**Subject:** 110412 FAI 037 Safety Project D5 Requests Cost Proposal ASAP

**Subject:** RE: FAI-37-6.34 Preliminary Right of Way Plans (PID No. 110412)

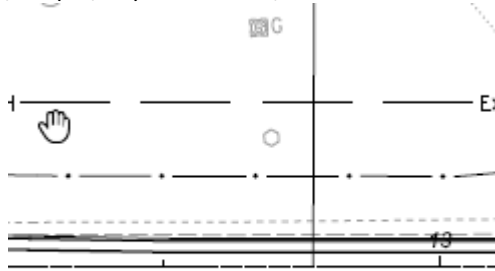
- Missing sheet 20 of 37 as Luke stated.
- Page 21/36 (22/37) Parcel 11-SH shows "Utility Pole Save" for private light poles. I would have them removed as ODOT will need to pay for them anyways (in take area) and would need to do a permit (not recommended) for the poles that are very close to the fence needing removed. Same Parcel has three of those poles (not 2) and also has a small sign near the fence that was not picked up on these plans:
